ADDENDUM NO. 1

Construct Field Maintenance Shop (FMS) Bay Addition

Fort Leonard Wood Readiness Center

PROJECT NO.: T2126-01

1 ABOVE FLOOR PLUMBING PLAN
3/16" = 1'-0"

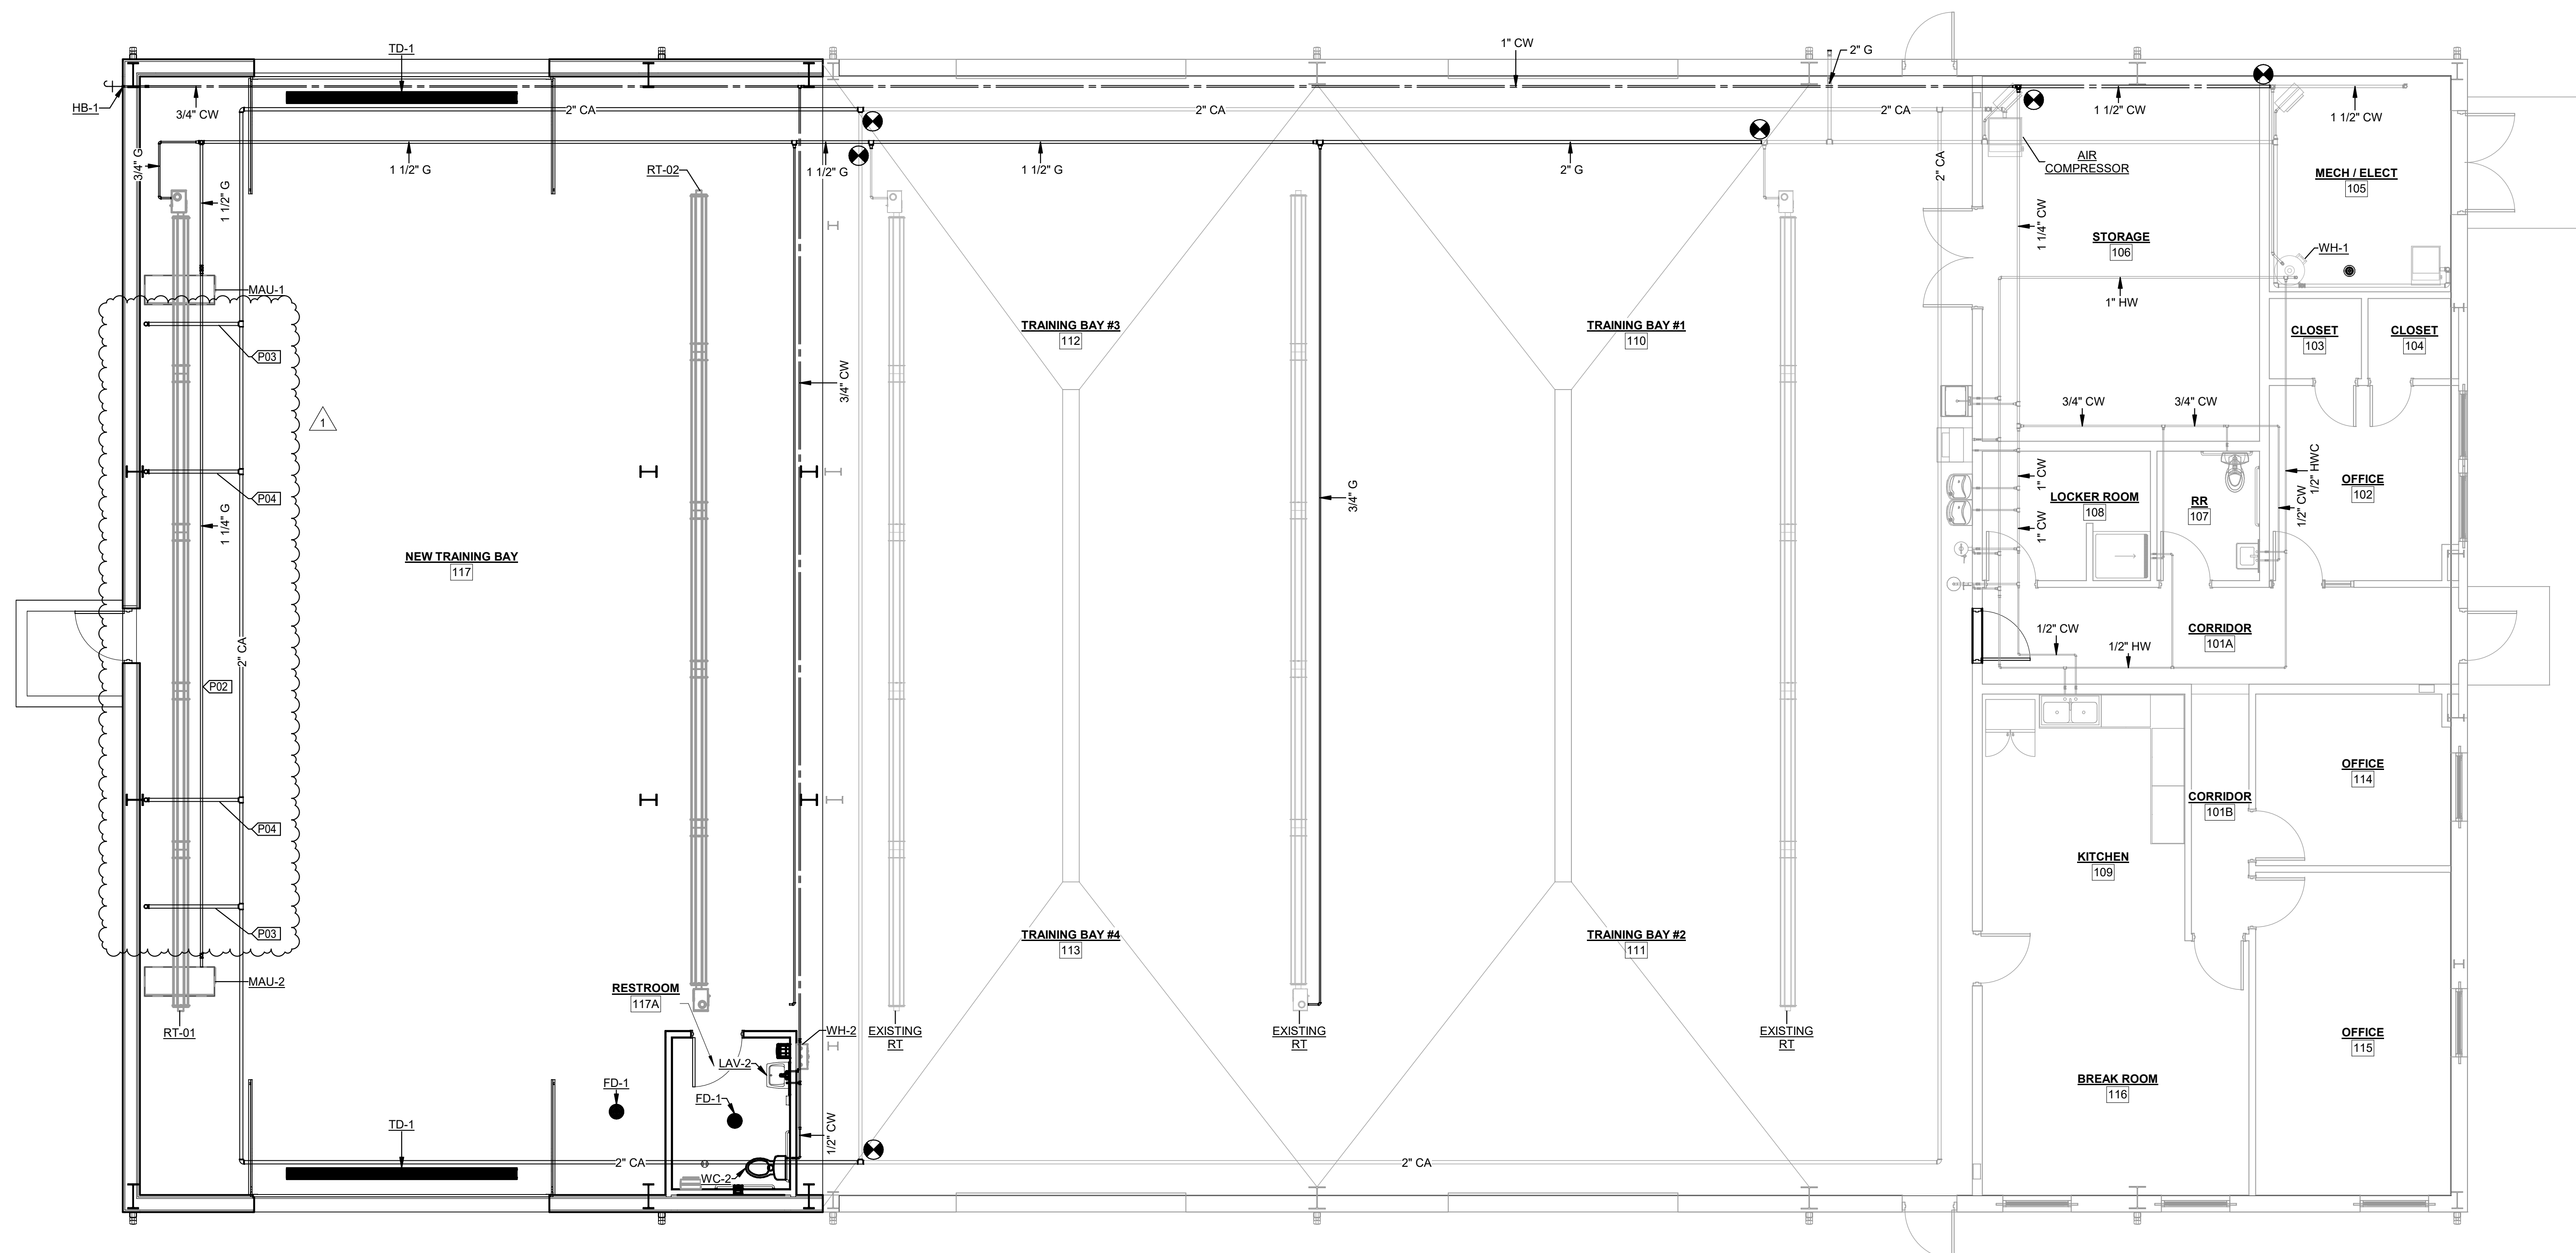
5. Sheet P102:

- a. ADD Key Notes as follows:

P03 INSTALL COMPRESSED AIR BRANCH PIPE WITH SPRING RETURN AIR HOSE REEL. FLEXIBLE HOSE LENGTH TO BE A MINIMUM OF 50FT.

P04 INSTALL COMPRESSED AIR BRANCH PIPE WITH FILTER AND PRESSURE REGULATOR. CONNECTION SHALL BE 4FT ABOVE FINISHED FLOOR.

1 MECHANICAL FLOOR PLAN

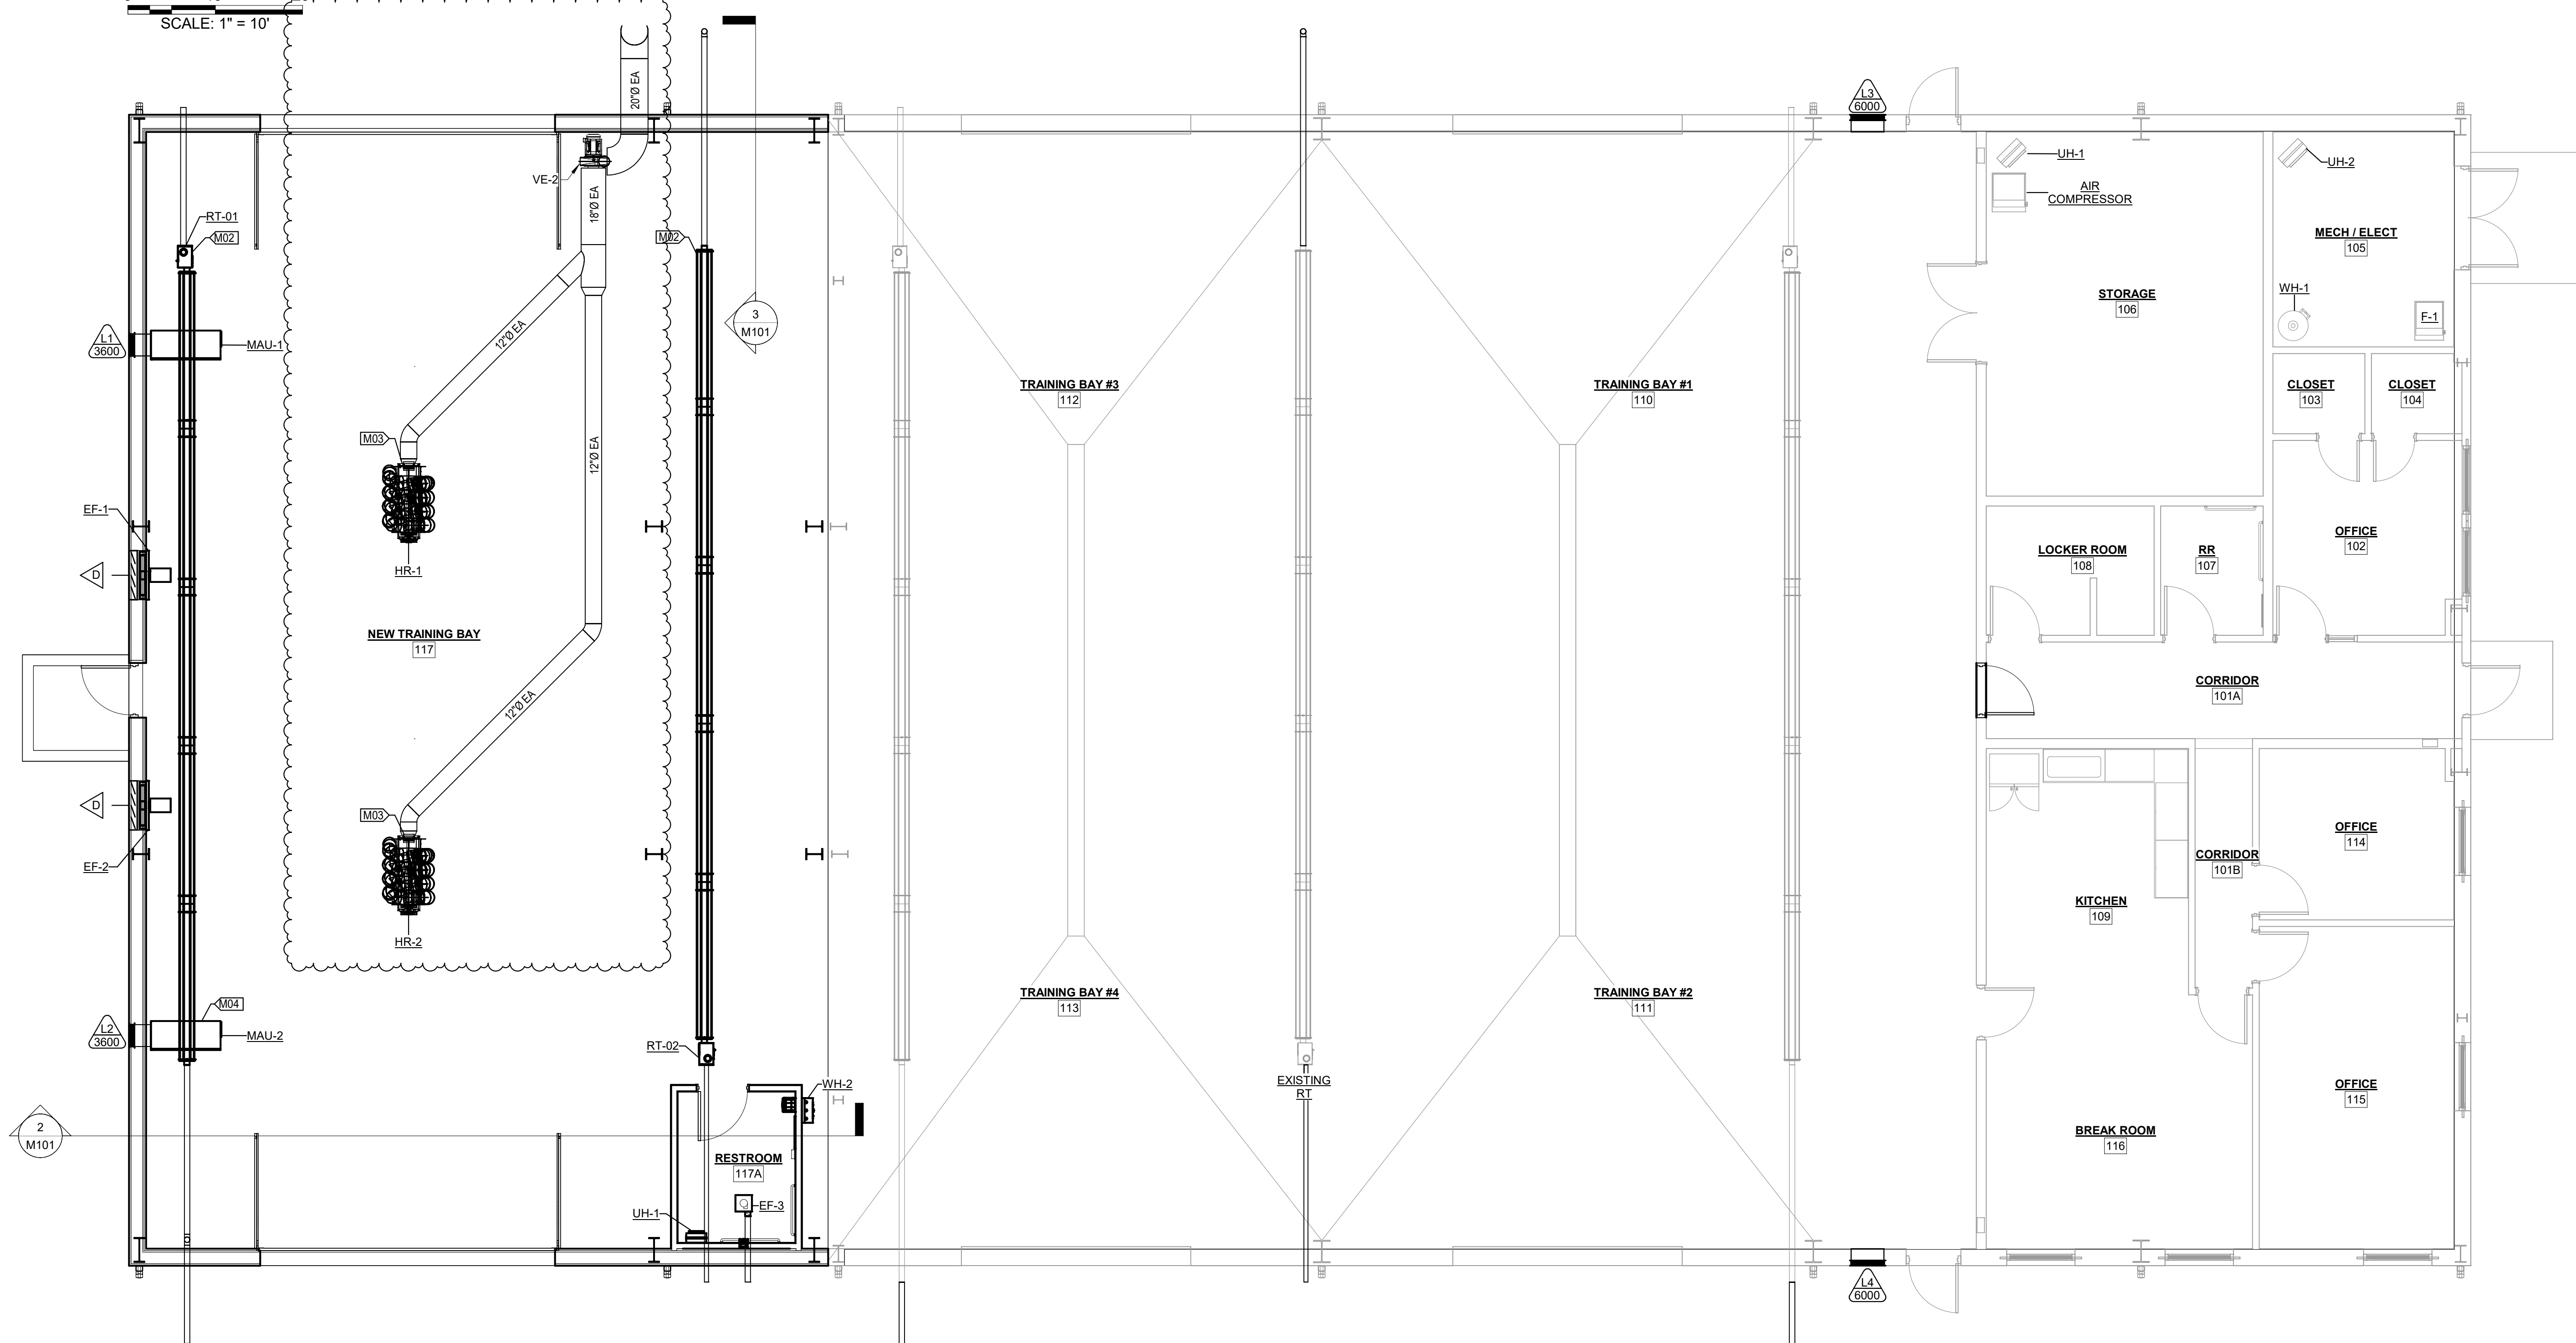
6. Sheet M101:

- a. MODIFY Vehicle Exhaust duct from 6" diameter round duct to 12" from each hose reel, 18" to fan, and 20" at fan discharge.
